Grading Plan Approved
shown and/or noted
T. MAS P. GILLES, P.E.
Lake County Engineer

GENTRY HOMES
CONCORD OH, 44077

SITEPLAN
BANNERSTONE DRIVE PAINESVILLE, OH. 44077
SUBLOT NO. 21 EASTERN WOODLANDS SUBDIVISION PHASE NO. 1

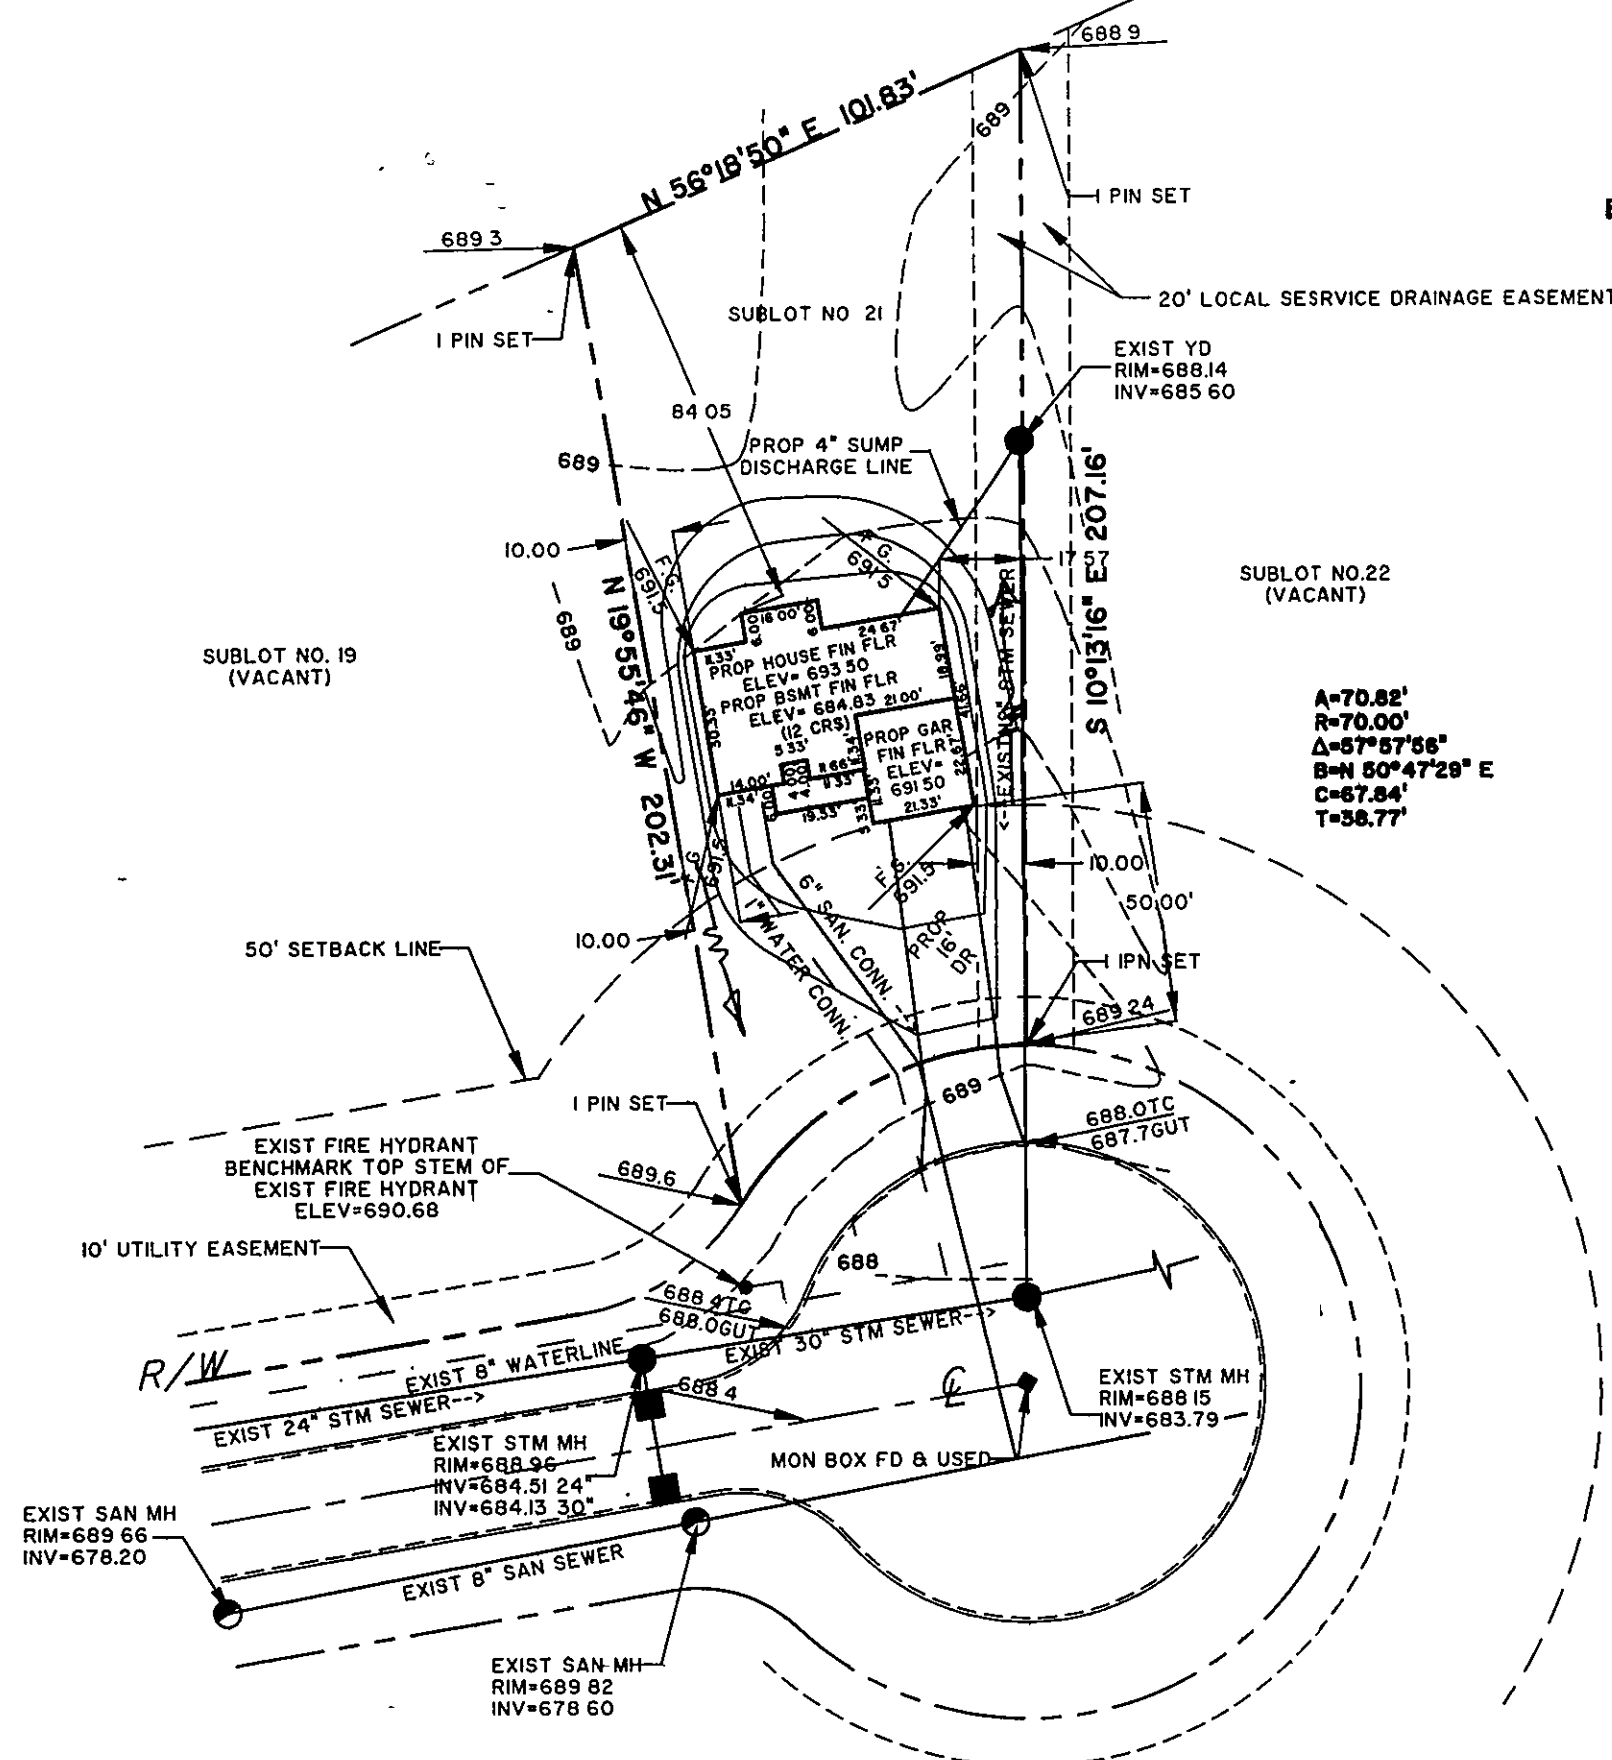
By TAM Date 5/7/99
Swale as shown
